**RE: NORTHPORT EXPANSION CONSENTS – RESPONSE TO SECOND REQUEST FOR INFORMATION**

**RE: NORTHPORT EXPANSION PROJECT (APP.005055.38.01 & LU2200107) – RESPONSE TO S92(1)  
REQUEST FOR INFORMATION**

This is a response to the two requests for information (RFIs) dated 19 December 2022 and 2 February 2023 respectively. The response is structured according to the headings and item numbers in the two RFIs.

Figure 3.11 Measured (top) and model (bottom) depth change after one year from 2016 to 2017.

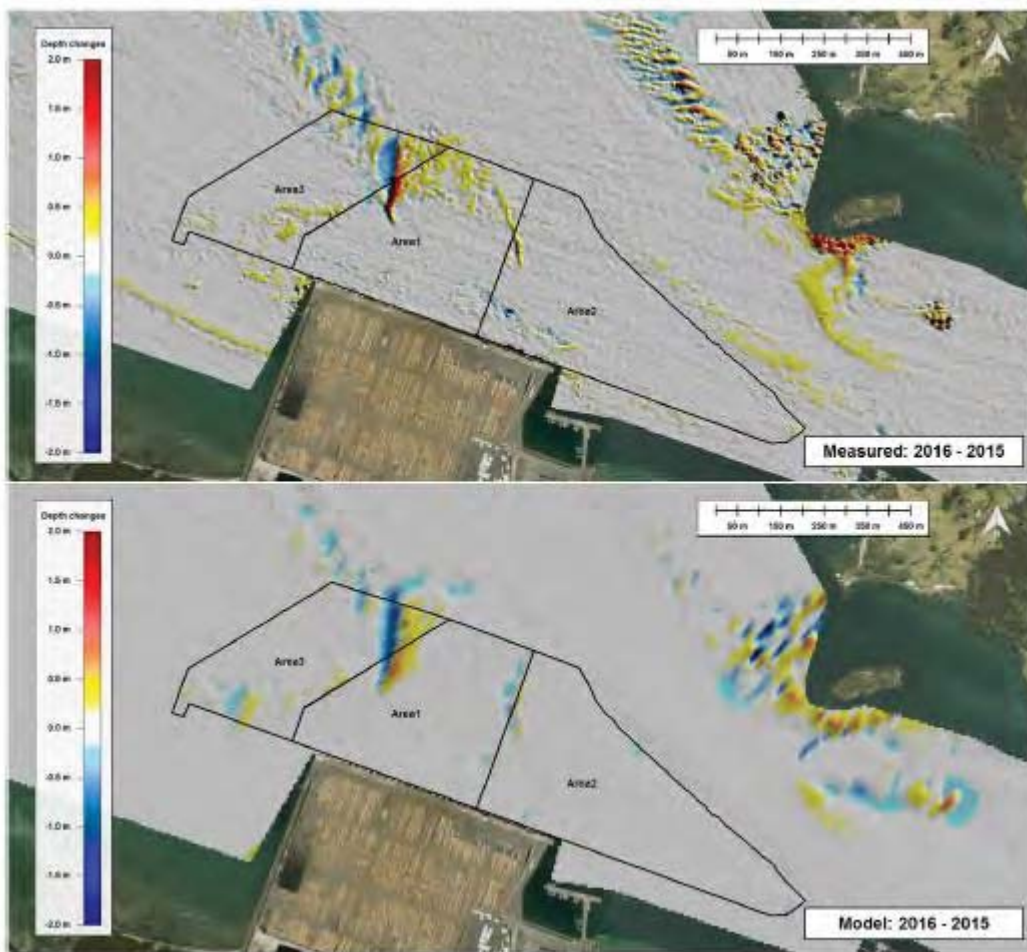
- 28.2 Single beam survey data from 2007 to 2014 were examined to better understand the infilling process occurring within the swinging basin at Northport. The Delft3D morphological model was then calibrated for changes observed between 2016 and 2017. Qualitatively, model results show a good agreement spatially with the measured morphological changes, with the model capturing the migration of Snake Bank into the swinging basin and the succession of erosion and accretion along the southern margin of bank (see Figure 3.11 below).

- 28.3 The high degree of stability observed elsewhere in the channel was relatively well reproduced in the predictions, as is the strong activity over the deep area adjacent to Motukaroro Island. Quantitatively, the accretion of sand from the tip of Snake Bank into the swinging basin by bedload transport is somewhat under-estimated. It is likely that a lack of resolution in the model grid resulted in decreasing bed slope gradients which influenced greatly the bedload component of the sediment transport. Irrespective, within the order of magnitude of errors expected for hydrographic surveys, the model showed a good capability in predicting realistic volumetric infilling rates within Areas 1 to 3; +8,128 m<sup>3</sup> and +3,658 m<sup>3</sup>, respectively (see Table 3.3 below).

- 28.4 Within Area 2, the morphological model predicted a similar order of magnitude in the total bed erosion to that observed (i.e. 2,500 m<sup>3</sup> and 1,600 m<sup>3</sup> respectively, see Table 3.3 below). The successful validation of the morphological model indicates that the modelling approach is applicable for examining both the existing morphological evolution and the response of the system to the proposed dredging and reclamations.
